TVA-SQN-TS-06-03

**SEQUOYAH NUCLEAR PLANT (SQN) - UNITS 1 AND 2 - TECHNICAL SPECIFICATIONS (TS) CHANGE 06-03 "ULTIMATE HEAT SINK (UHS) TEMPERATURE INCREASE AND ELEVATION CHANGES"**

### TENNESSEE VALLEY AUTHORITY (TVA) SEQUOYAH NUCLEAR PLANT (SQN) UNITS 1 AND 2

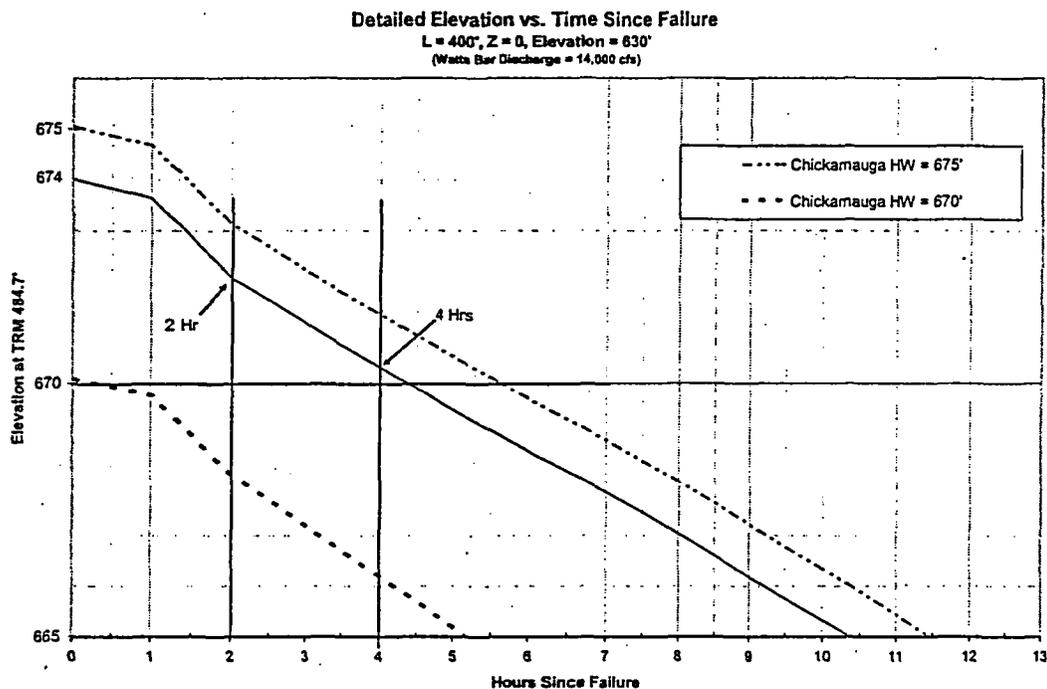
TVA has reviewed the recent ERCW flow balance and flow modeling (performance data). The review concludes that the components flow balanced at a river elevation of 670 feet are capable of supplying cooling water flow to support both short-term and long-term cooling needs following a LOCA and LODD. Also, a lower river level can supply the required minimum safety-related flows to the CCS and CS system heat exchangers without loss of net positive suction head; however, less operating margin exists which impacts operating fouling factors and requires removing equipment from service more frequently for flushing and biocide injections. TVA proposes a minimum river level of 674 feet for this UHS change request. An UHS elevation of 674 feet is conservative at 87°F, with regards to current analyzes and equipment performance data, to support essential heat loads following the accident events and provides at least 4 hours of river level above 670 feet following a LODD event (References 6 and 7). The below figure shows the river elevation change after the LODD. These

results are from Reference 8 with an overlay drawn-down curve for a river elevation starting point of 674 feet. A provision of 4 hours above the 670-foot system flow balance is adequate for compliance with the TS action statement, where the plant would be placed into Hot Standby (Mode 3) and in Cold Shutdown (Mode 5) within the following 30 hours, because lower river levels can supply the required minimum safety-related flow rates.
